BEACH FRONT APARTMENTS  
**CABLE BAY RESORT**  
ST. KITTS

**BEAM ELEVATIONS  
& DETAILS**

| Date     | 2005.11.30  | Drawing No.:  | S07A        |  |

**SECTION (1-1)**

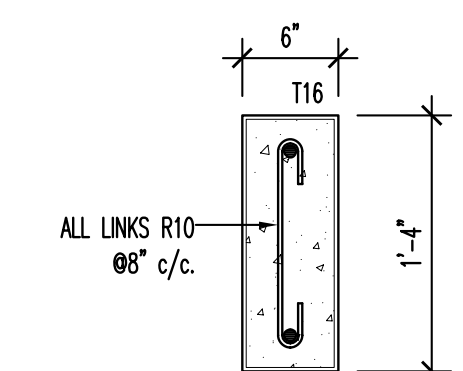
COVER TO REINFORCEMENT  
SHOULD BE 2"

**SECTION (2-2)**

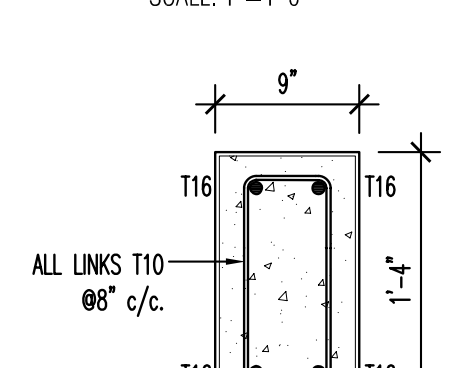
COVER TO REINFORCEMENT  
SHOULD BE 2"
